Goals- Revised Masterplan

JORDANELLE RIDGE

Revised Master Plan

Concerns/Questions:

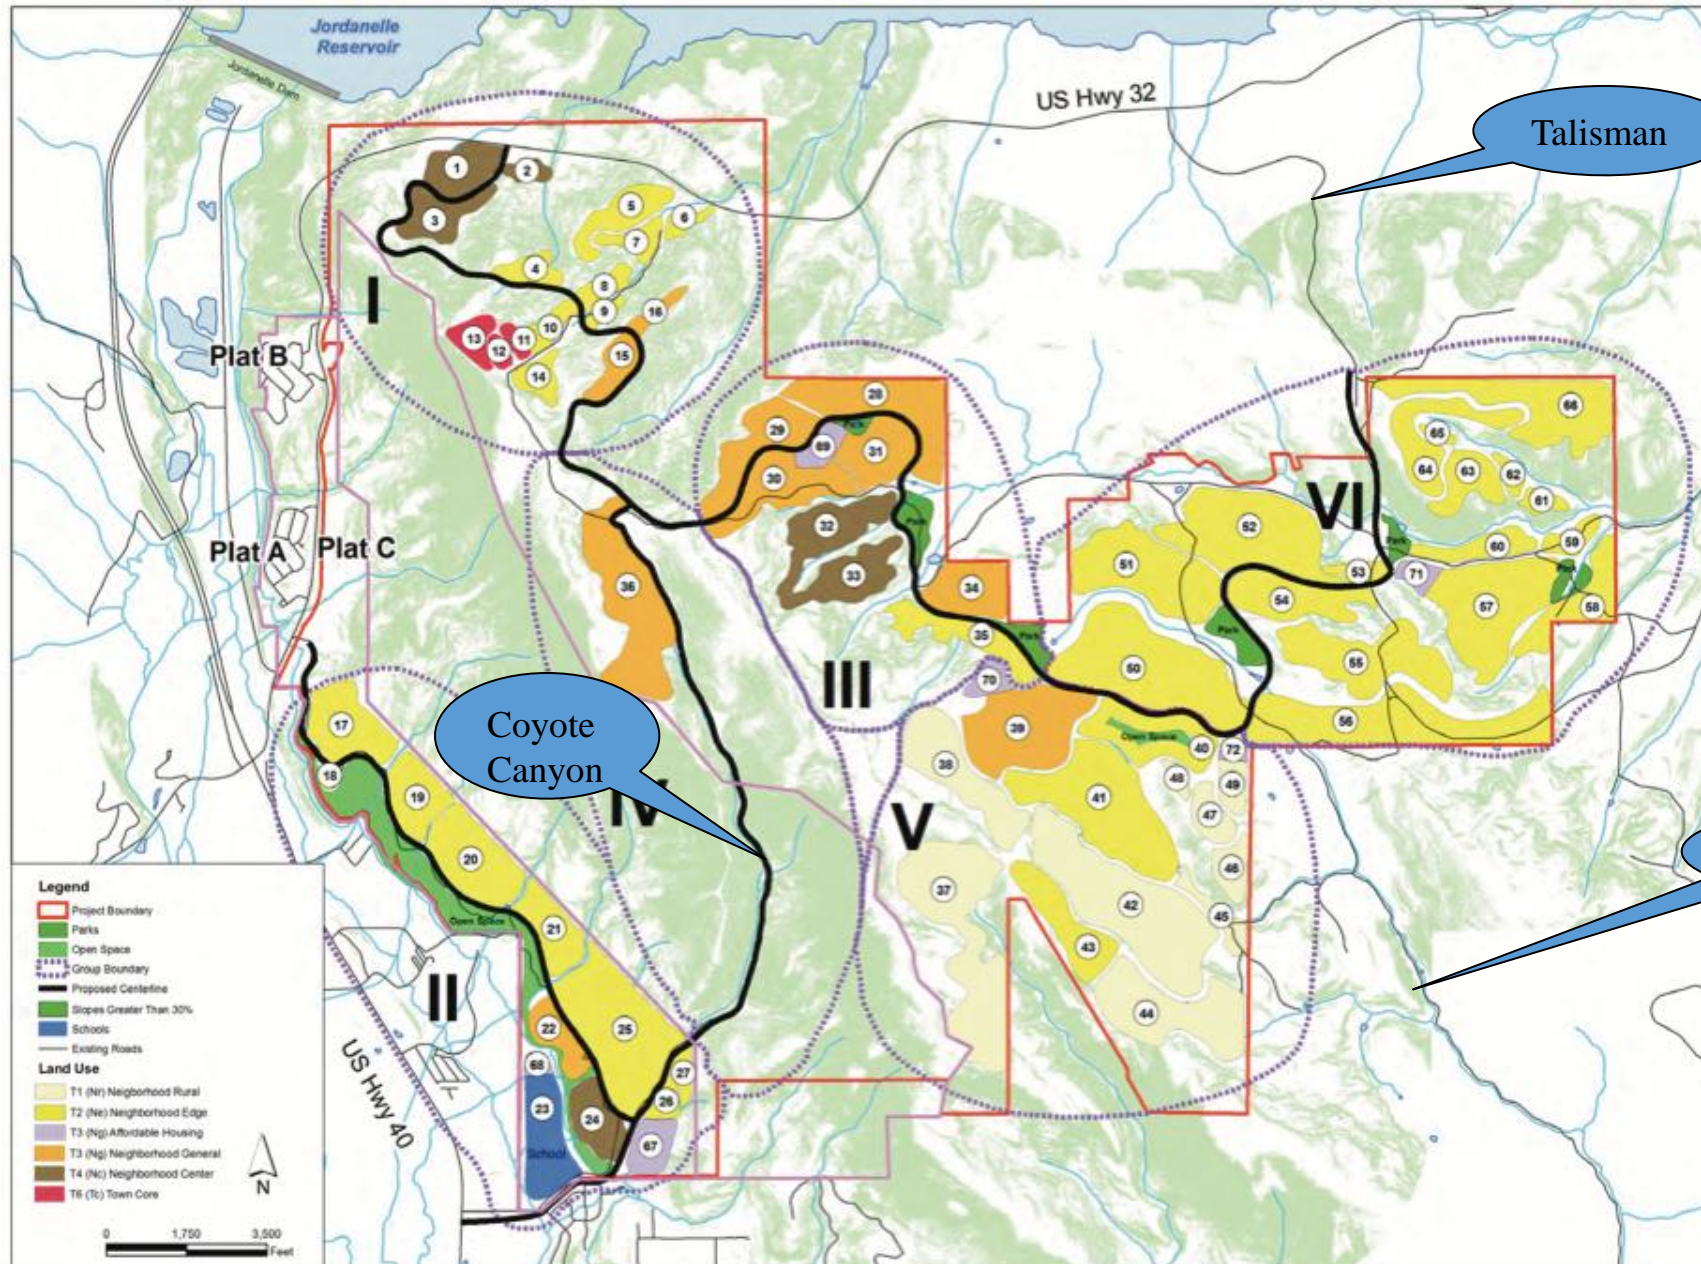
- Municipal services are expected for roads and parks.
- Access down little pole should be discouraged due to the traffic on Lake Creek. Approximately 16,000 ADT should not be dropped into Lake Creek Road at the east end of the valley.

- Improvements down Coyote Canyon must be in compliance with County standards. The traffic analysis anticipates 6-7,000 ADT. This road should be designed at the highest design speed possible according to our traffic engineer.

Talisman platted public right-of-way

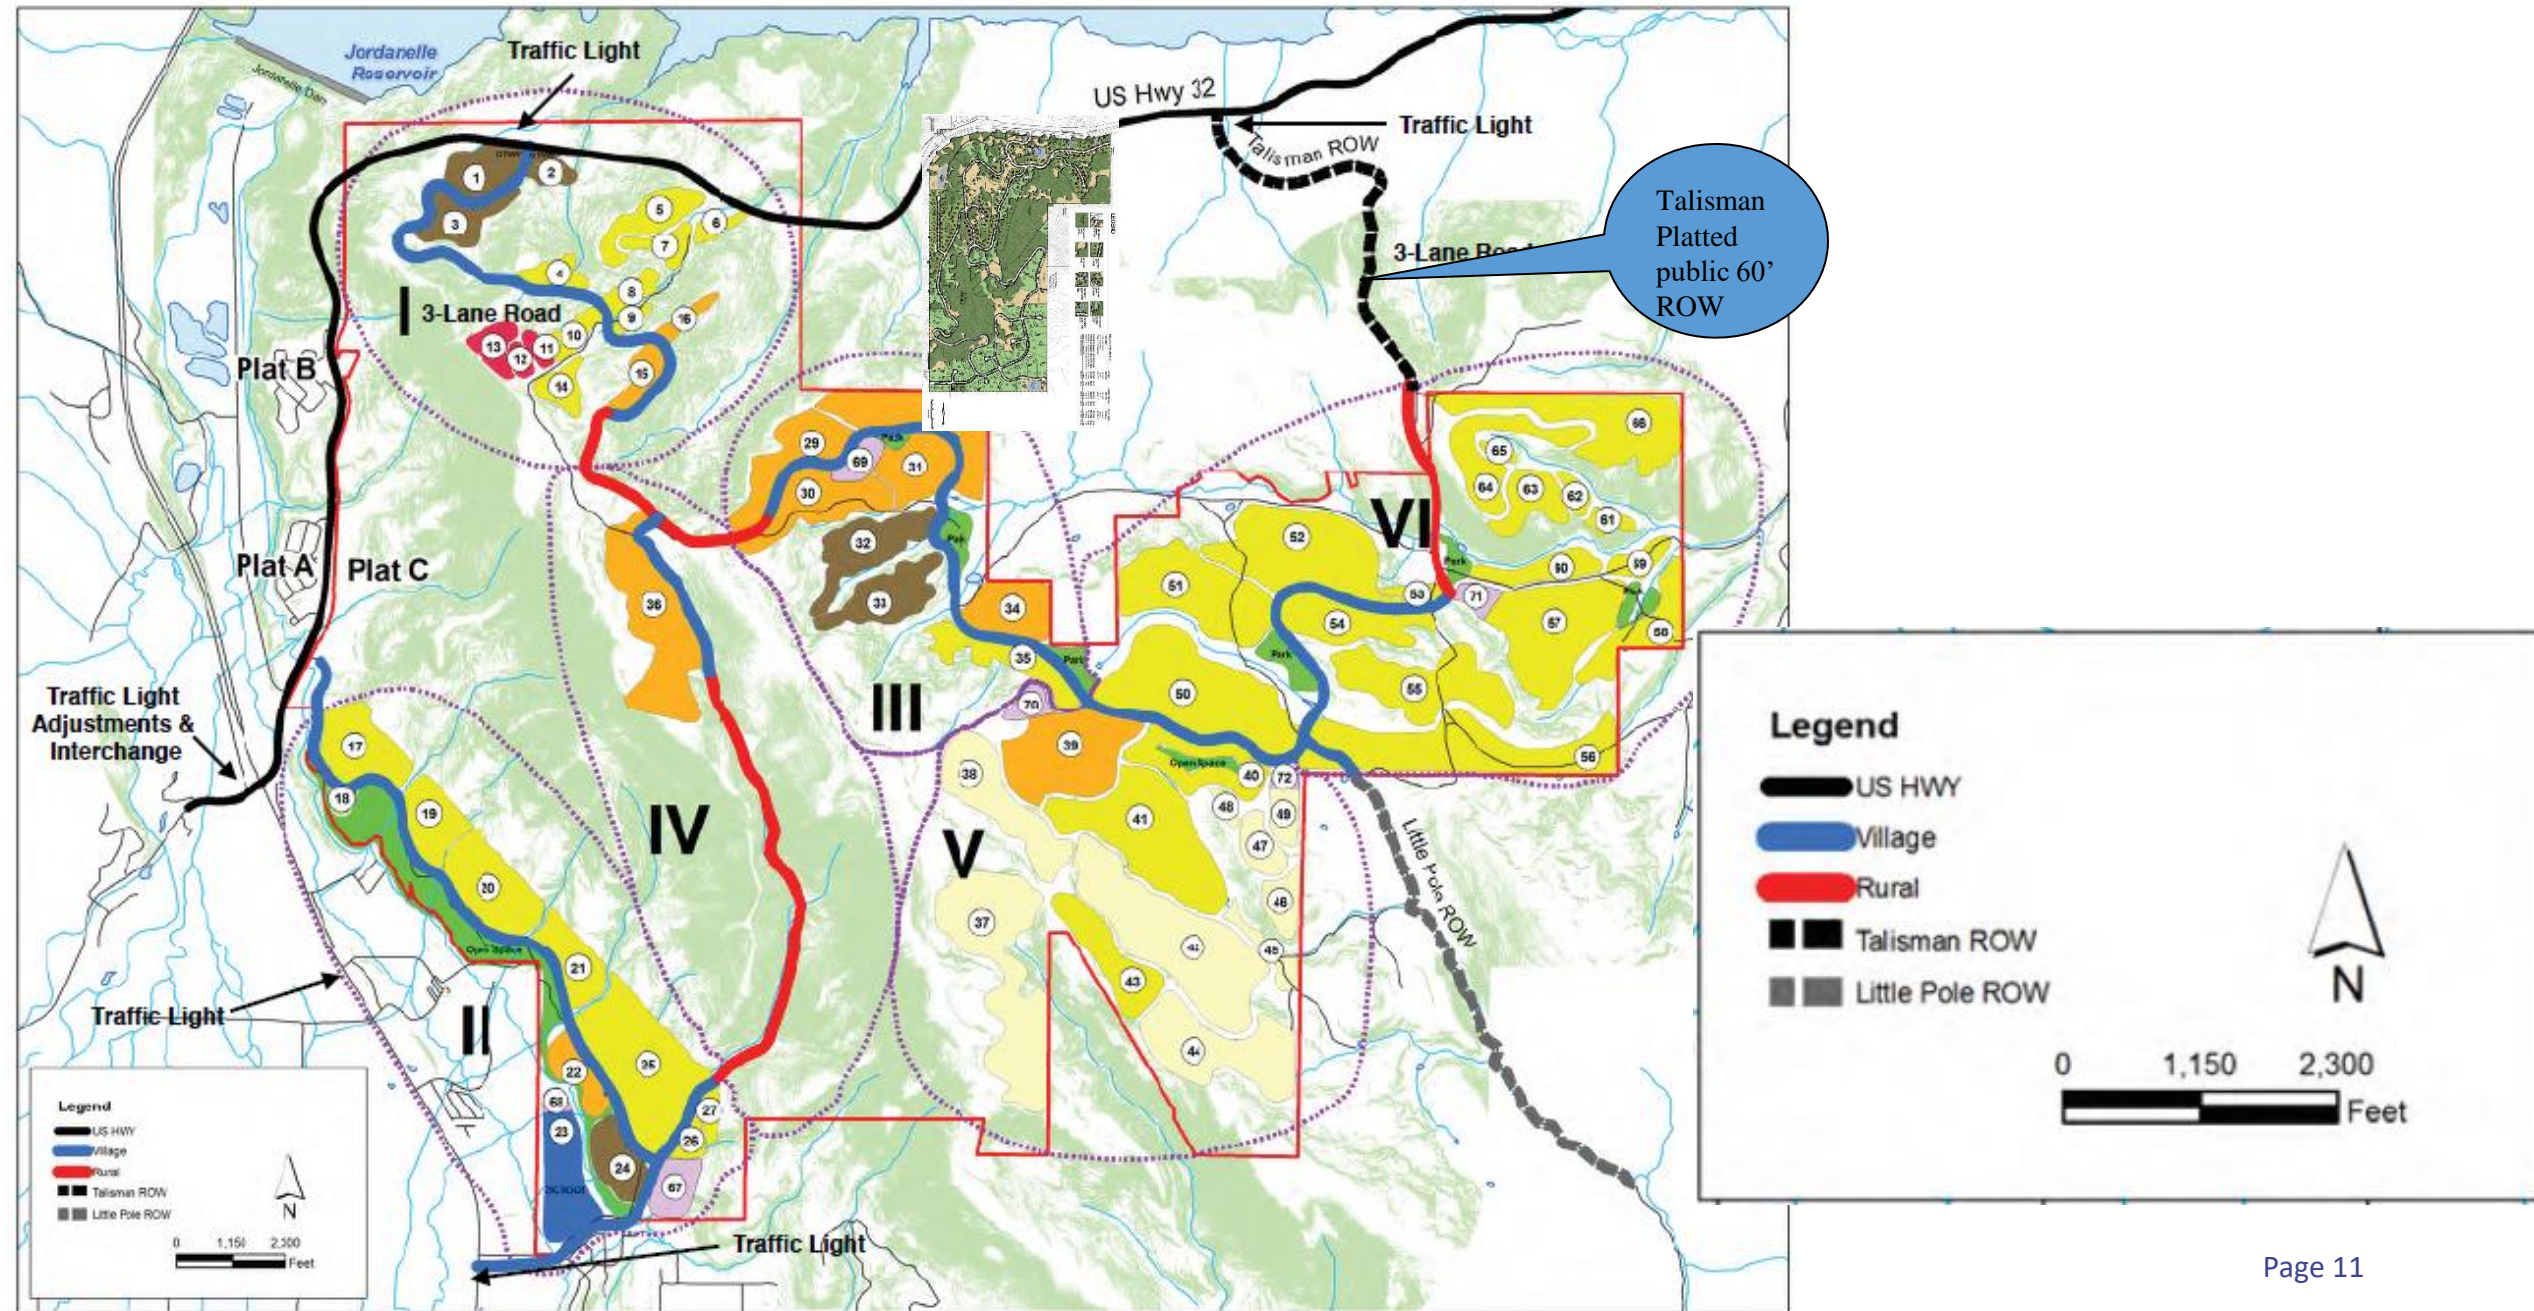
- Second home to a primary home development and impacts to the County.
- Access through the Talisman development must be possible. A transportation plan should be approved showing the connection to the public road and an agreement with the County that the road will not be vacated.
